BID ADDENDUM NO. 1

December 15, 2025

Corning-Painted Post Area School District
2025 Bus Garage, Admin & Stadium Alterations
2649.154

The following Addendum items shall be considered as part of the contract documents prepared by HUNT ENGINEERS, ARCHITECTS, LAND SURVEYORS & LANDSCAPE ARCHITECT, DPC.
Bid Document date of 11/13/2025.

REVISION IMPROVEMENT NOTE 11

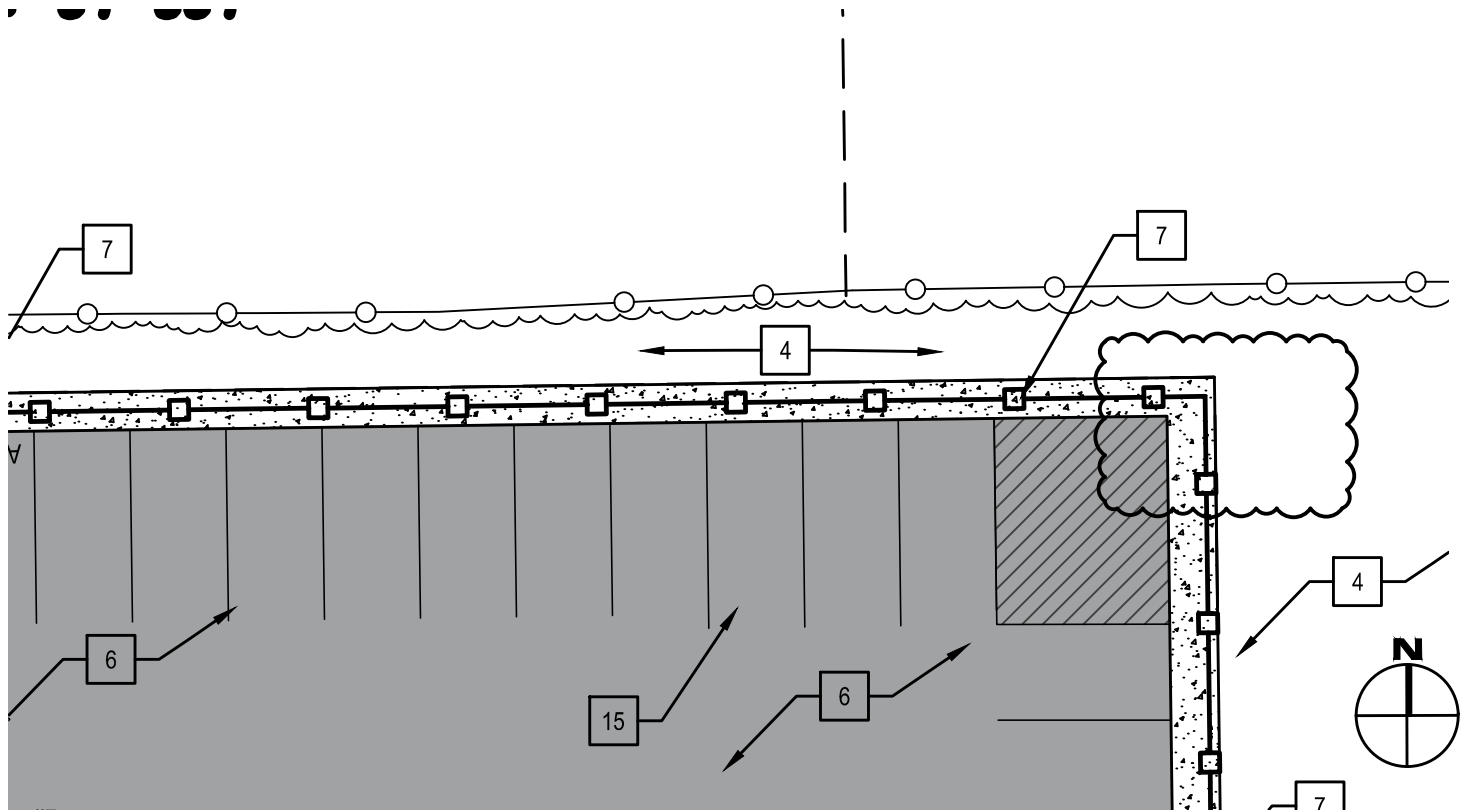
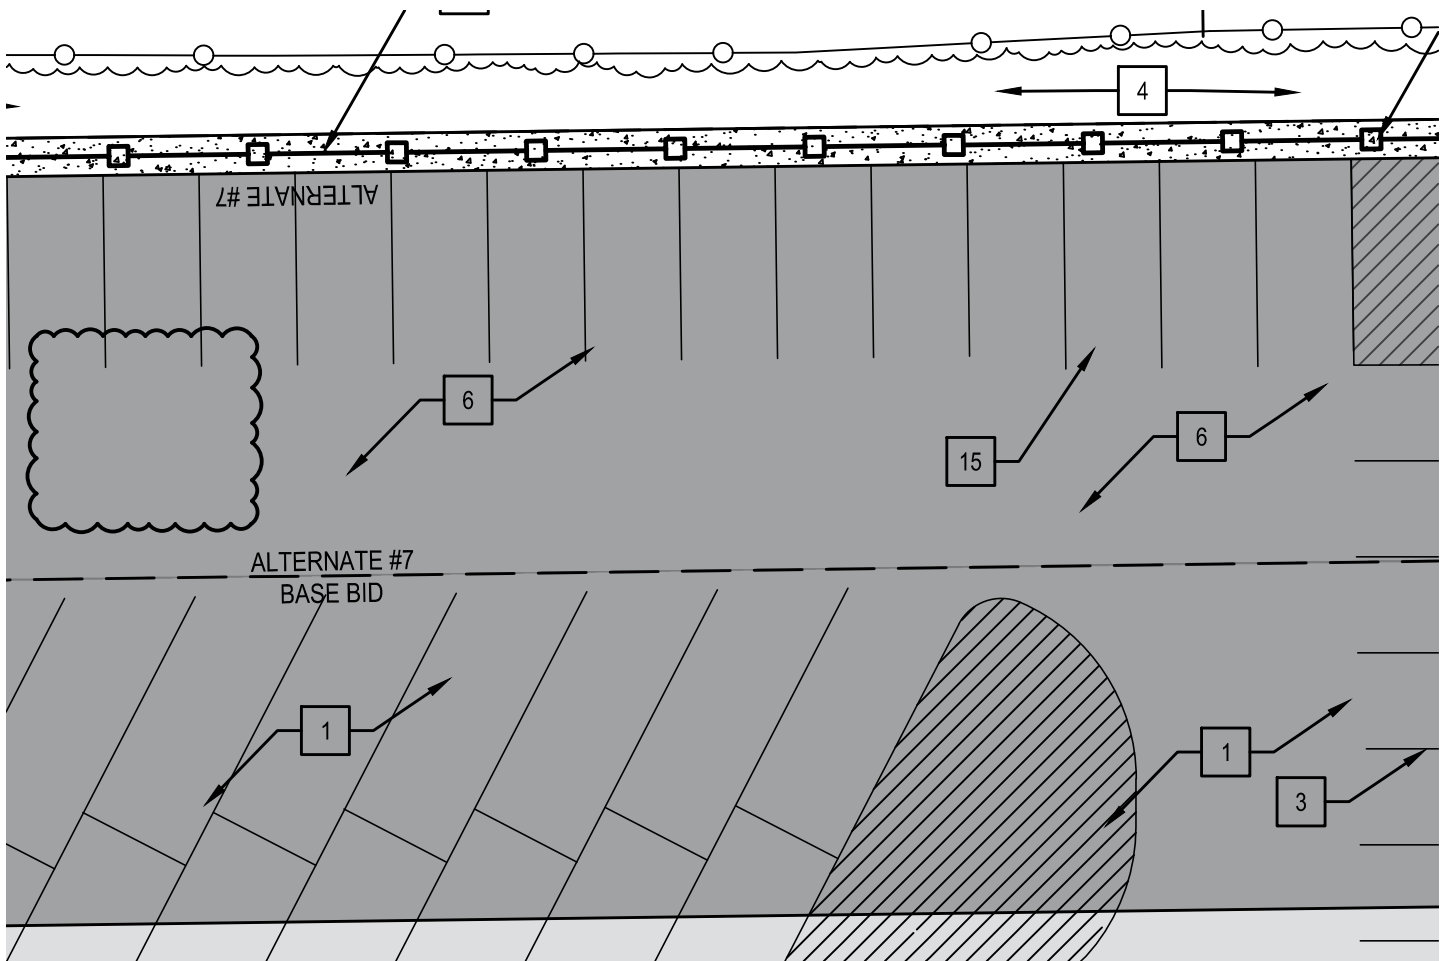
ITEM AD1-19 Refer to BG-L21 - SITE IMPROVEMENT PLAN

AMMEND Improvement Note #10: “1/2” ” to read “1 ½” ”.

ITEM AD1-21 Refer to BG-L21 - SITE IMPROVEMENT PLAN

ADD Drawing: "AD-L1 REVISION IMPROVEMENT NOTE 11" as attached in this addendum

CONCRETE GENERATOR PAD DETAIL

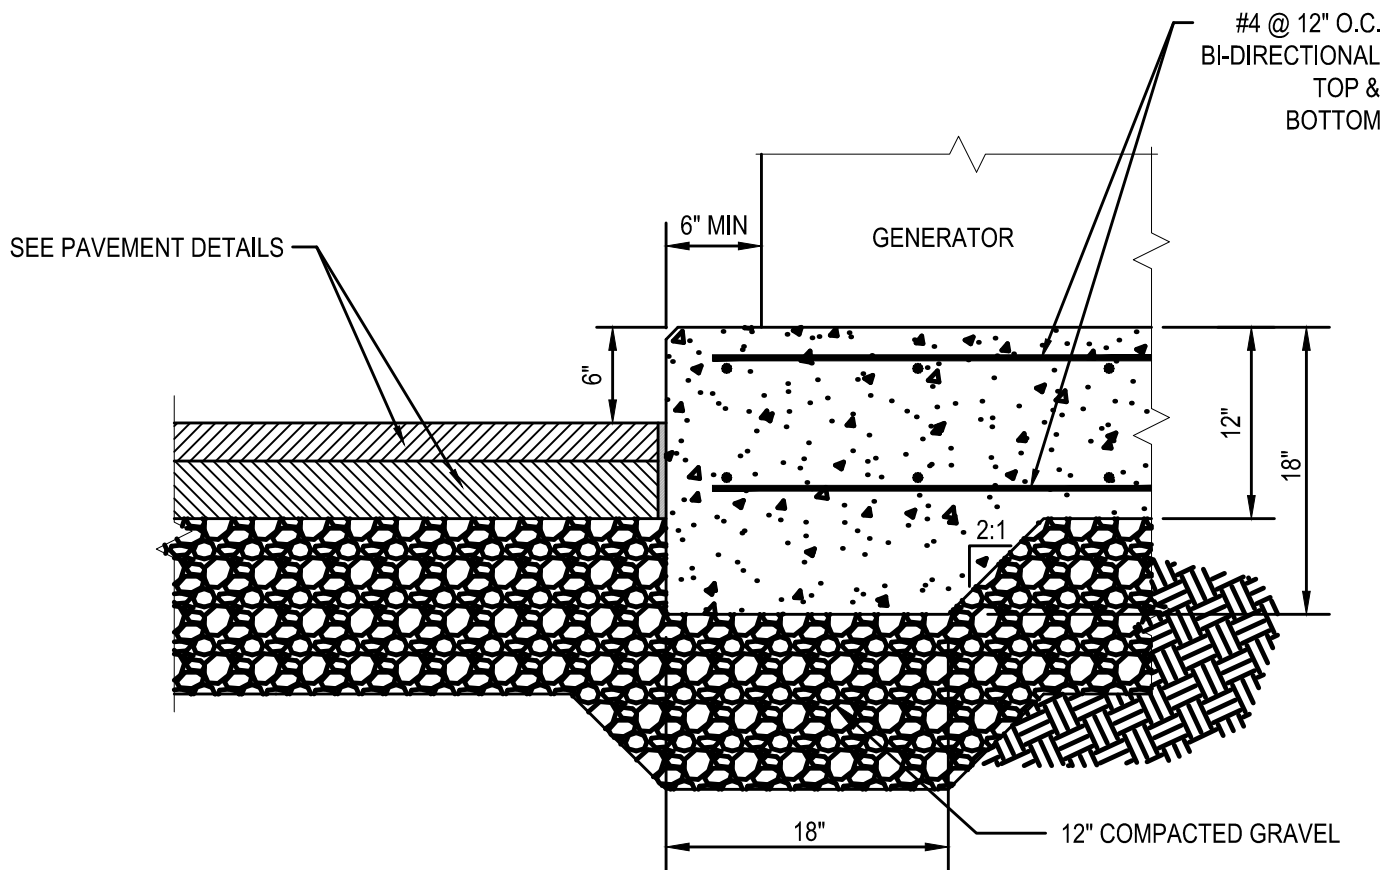
ITEM AD1-24 Refer to BG-L5.1 SITE DETAILS

ADD Drawing: "AD1-L2 GENERATOR PAD DETAIL" as attached in this addendum
